**DTE Energy®**

July 29, 2015  
NRC3-15-0006

Subject: DTE Electric Company Report of Fermi 3 QAPD Changes

Attachment 1 – Description of QAPD Revisions 5, 6, 7, and 8  
Enclosure 1 – Fermi 3 QAPD, Revision 8

**Figure II.1-1  
Fermi 3 Pre-COL and Transition from Pre-COL  
to Design and Construction Organizational  
Structure**

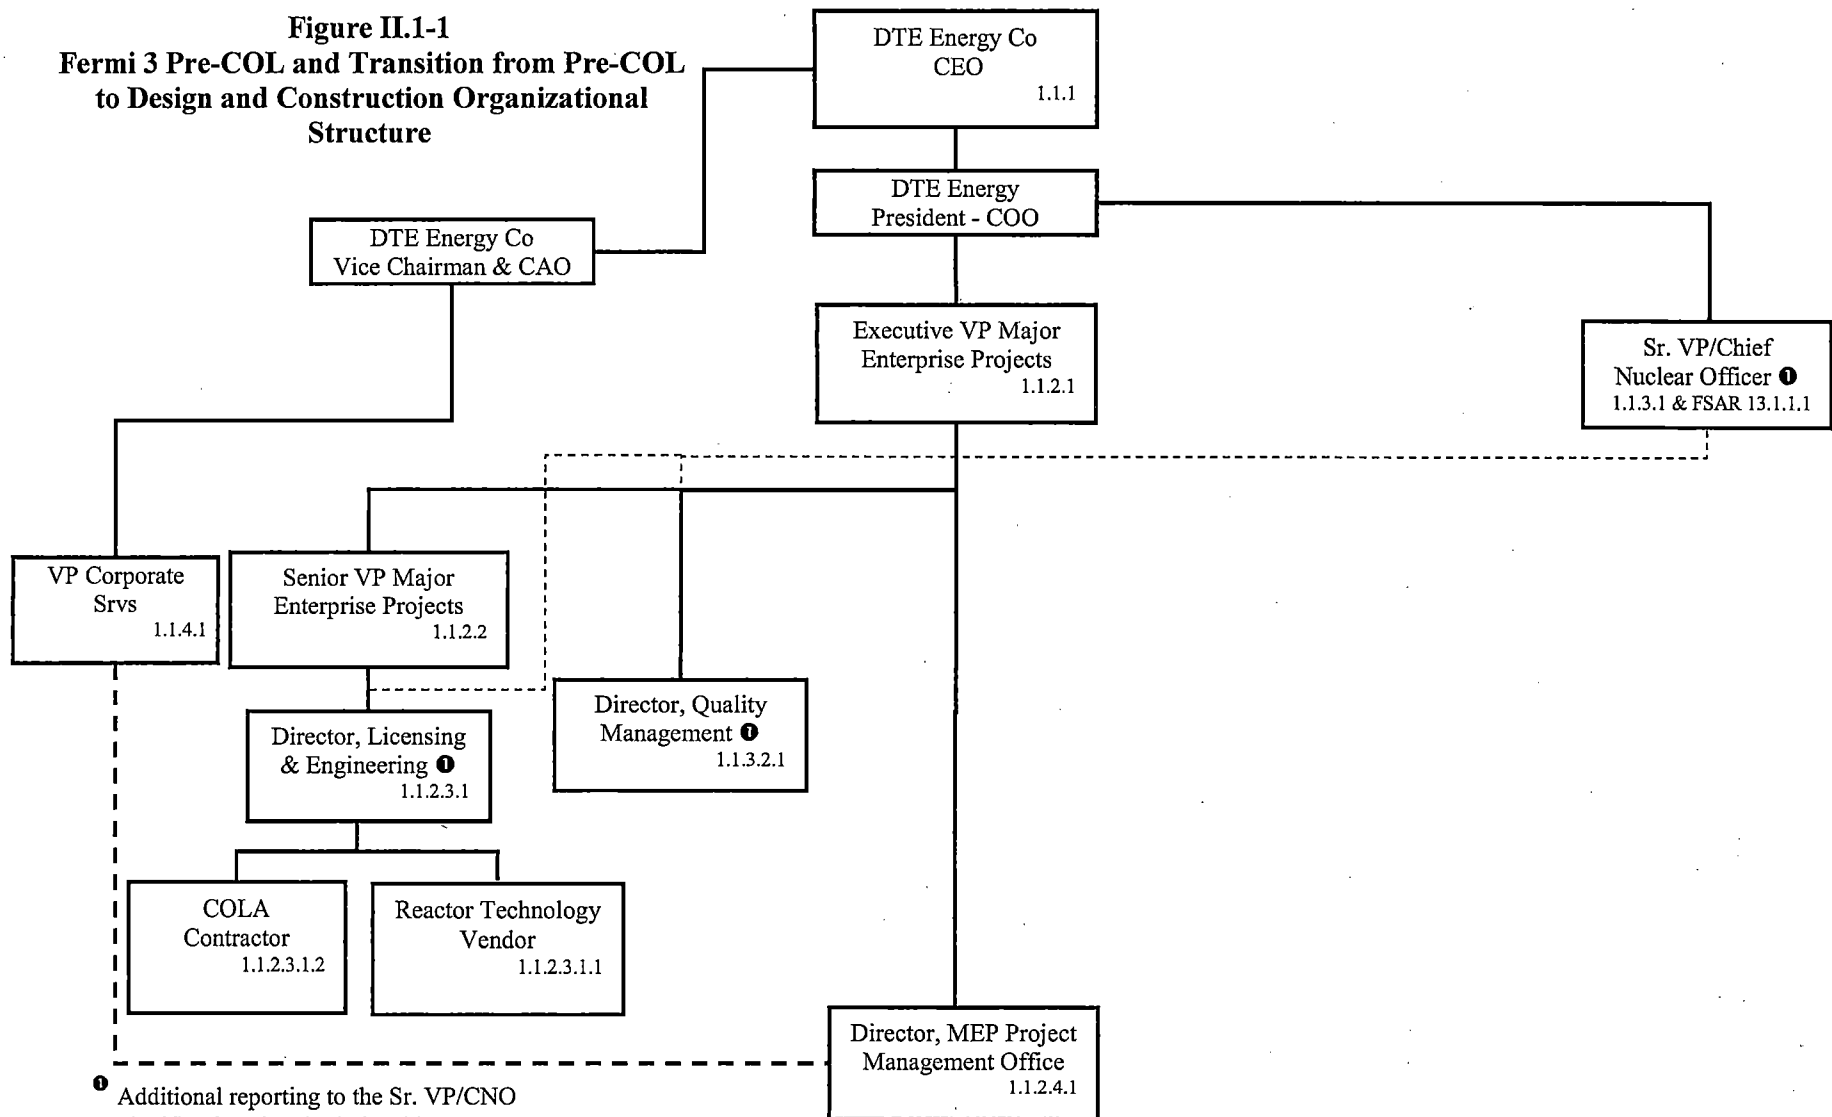
Revision	Description
7	<p>This revision incorporated Nuclear Development Organization structure changes for the transition to the design and construction activities of Fermi 3. The Change is a result of the Pre-COL organization being extended through the transition to design and construction.</p>
8	<p>This revision incorporated the following changes:</p> <ol style="list-style-type: none"><li>1) Director of Licensing and Engineering, was a direct report to the Executive VP MEP, and will now be a direct report to the SR. VP MEP</li><li>2) Title of the Pre-COL Organization Section is being revised to include, COL Organization during Transition to Design and Construction</li><li>3) The title of the Director, Quality Management was changed back, because it was inadvertently changed to Vice President, Quality Management in a previous revision</li></ol> <p>This change is a result of a change to the reporting structure within the Major Enterprise Projects (MEP) Department of DTE Energy and to correct a title change that was made in error. The overall management responsibilities of the Fermi 3 organization and the QAPD remain under the Executive VP, MEP.</p>

Rev 8 – Incorporates a change to the MEP organizational reporting chain during the Transition to the Design and Construction activities of Fermi 3; the Director, Licensing and Engineering previously reported to the Executive VP MEP and will now report to the Senior VP MEP. This revision also incorporates a change to the Pre-COL Organization Section Title by adding, COL Organization during Transition to Design and Construction for clarification. A change was also made to the title of the Director, Quality Management to change the title back, because the title was inadvertently changed to Vice President, Quality Management in a previous Revision (see CAR 6730334).

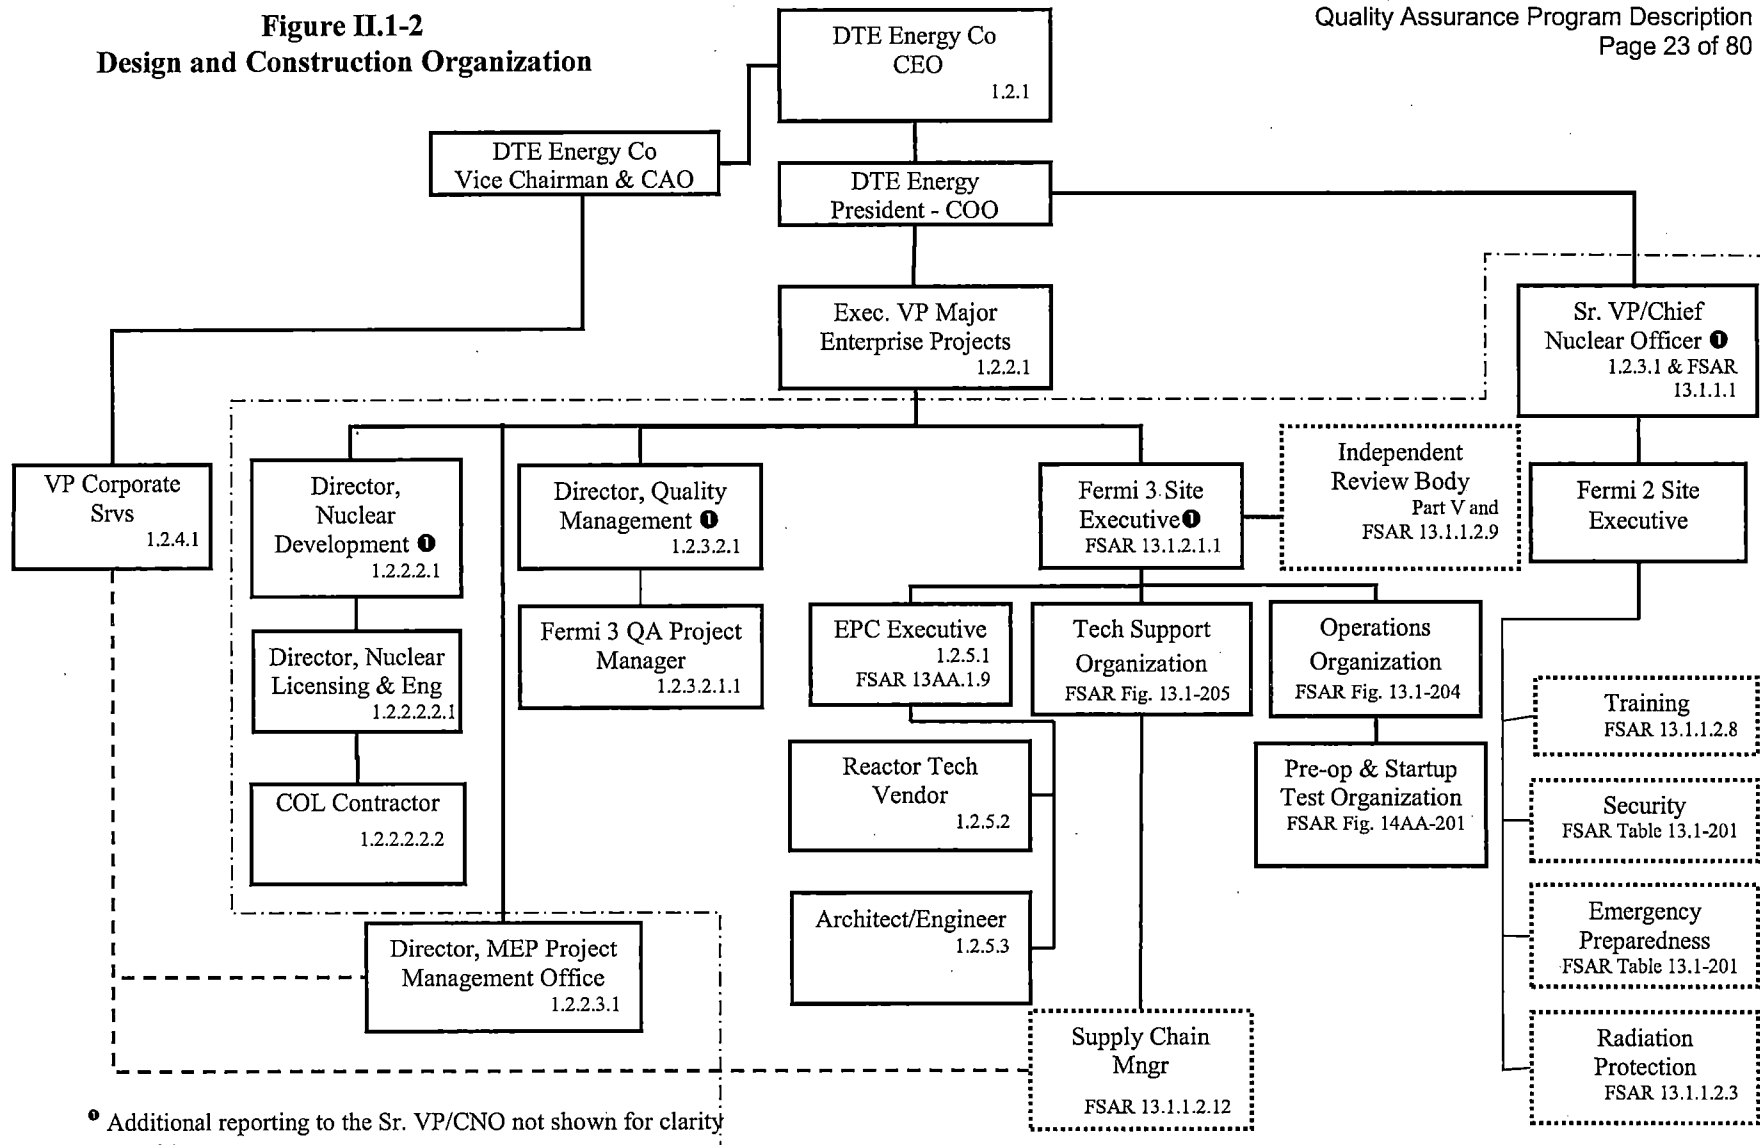
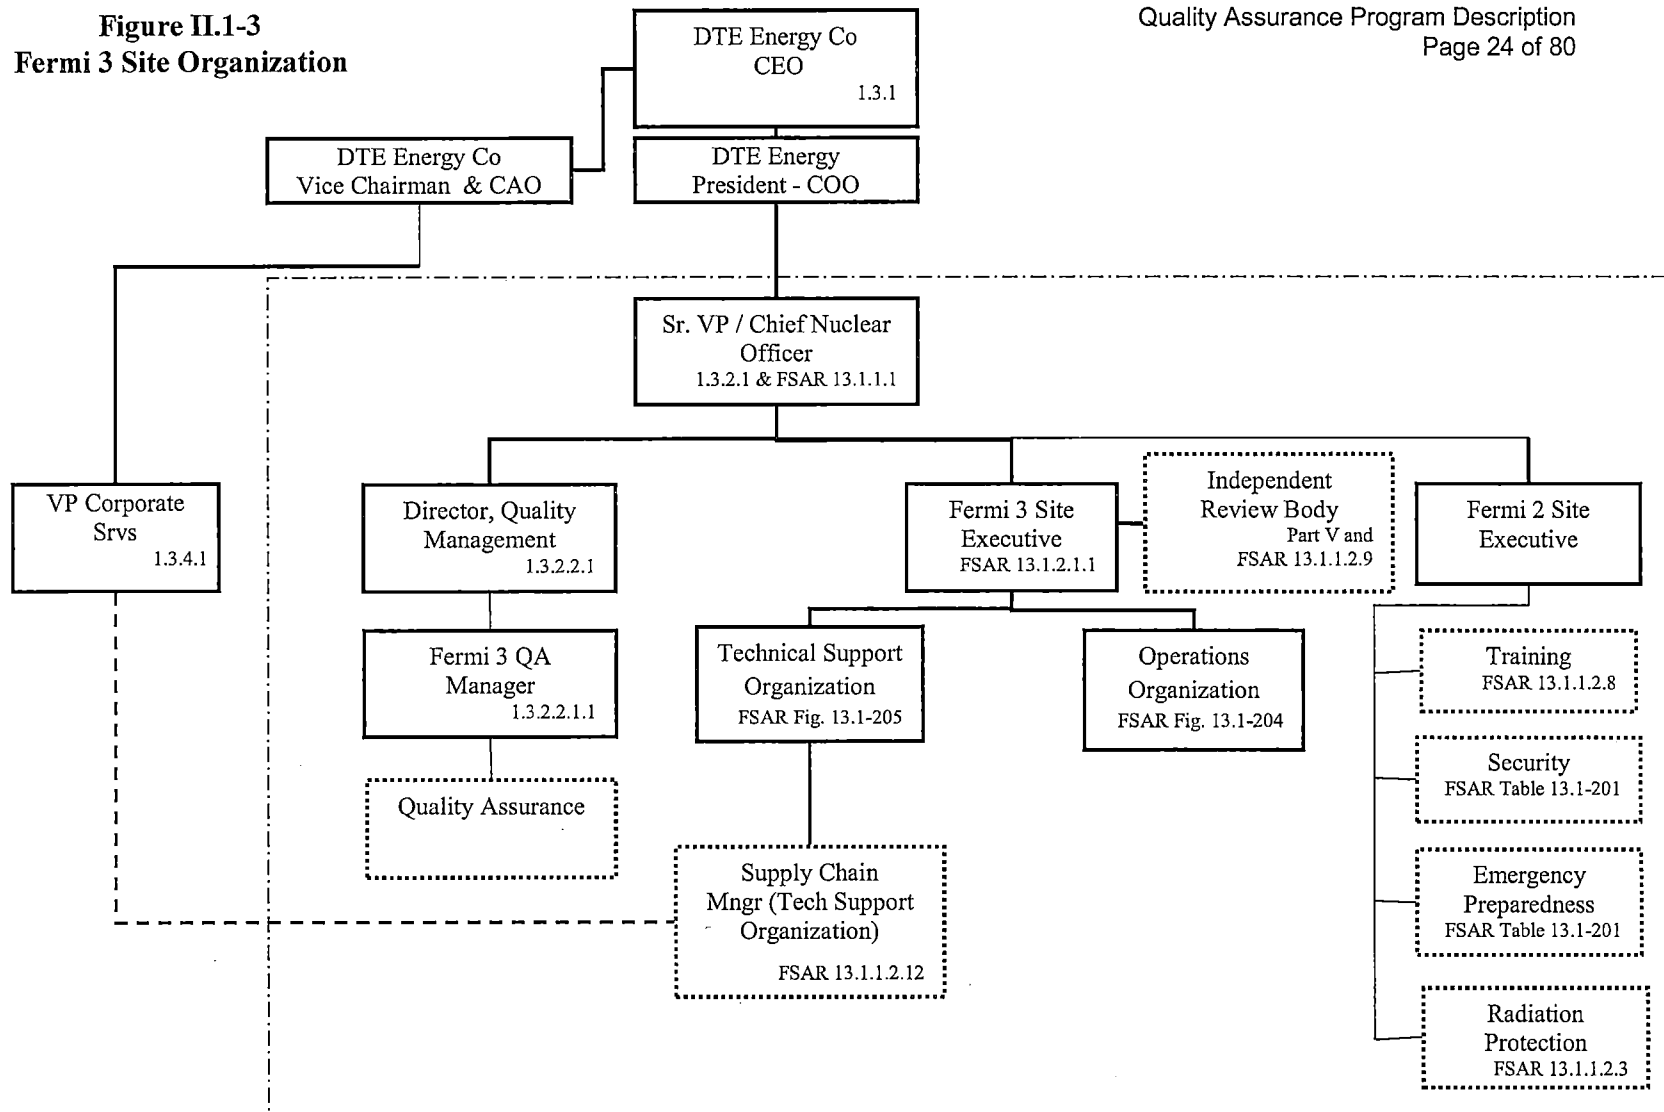
6	<p>This revision incorporated the following changes:</p> <ol style="list-style-type: none"> <li>1) Detroit Edison Company changed to DTE Electric Company or DTE Energy</li> <li>2) Senior Vice President Major Enterprise Projects title was changed to Executive Vice President Major Enterprise Projects</li> <li>3) MEP Program Office name was changed to MEP Project Management Office</li> <li>4) Position of Director, Corporate Services was changed to Vice President, Corporate Services and reports to the Vice Chairman and Chief Administrative Officer.</li> </ol> <p>Due to changes in the company name and organization, this revision changes Detroit Edison Company to DTE Electric Company or DTE Energy as appropriate and makes Executive Management and MEP organizational changes to QAPD document and Figures II.I-1, 11.1-2, and II.I-3.</p>
